URGENT MEDICAL DEVICE CORRECTION

Potential for Suspension of Dynamic Sensing Algorithm

Aurora EV-ICD™ (DVEA3E4) <UDI: 00763000368463>, Clinical EV-ICD (DVEX3E4)< 00763000217891>

29 October 2025 | 20:39 PDT

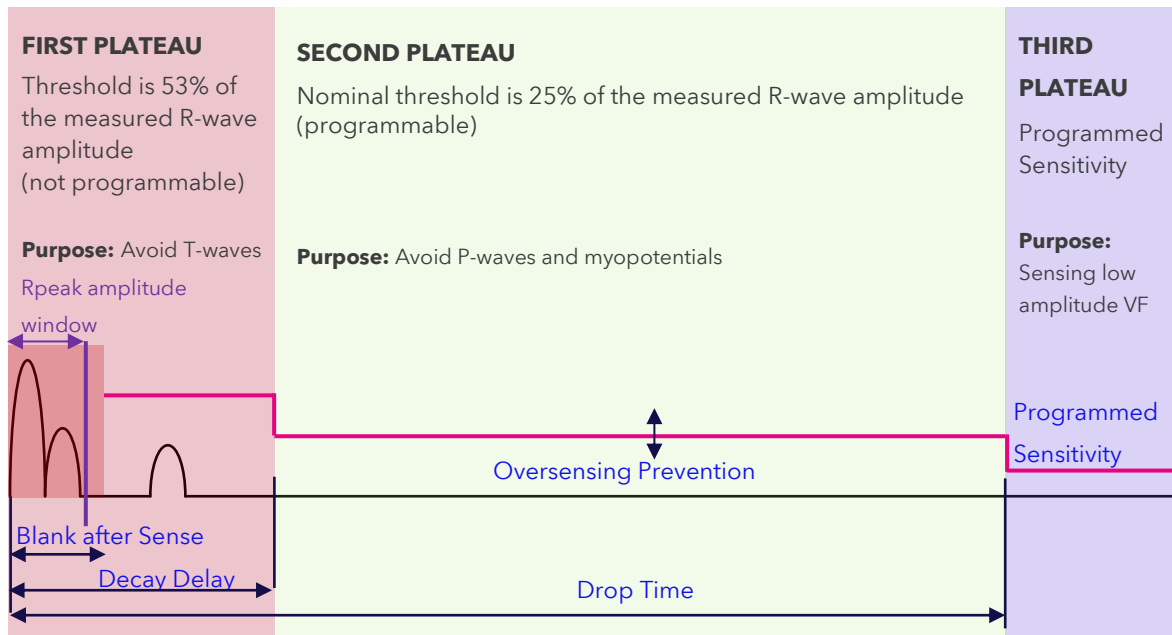
The Aurora EV-ICD dynamic sensing algorithm is unique due to the implant location within the substernal space. Figure 1 below illustrates how the device sets sensitivity beat-by-beat based on R-wave measurement of the rectified and filtered EGM.

The dynamic sensing algorithm may become suspended at the first plateau if the following sequence of events occurs:

1. Charge-end occurs within 128.75ms of the prior sensed beat, thus interrupting the in-progress R-wave measurement-**suspension of the dynamic sensing algorithm occurs and the sensitivity plateau becomes static at 53%.**
2. The sensitivity plateau will remain at 53% until a subsequent **R-wave amplitude exceeds this value.** In the case of a significant drop in R-wave amplitudes, delay in HV therapy delivery can occur.

Medtronic has implemented a software update in manufacturing. Devices manufactured with this update are not susceptible to this delay (see Appendix B). In previously distributed devices, the availability of the software update will be communicated upon regulatory approval.
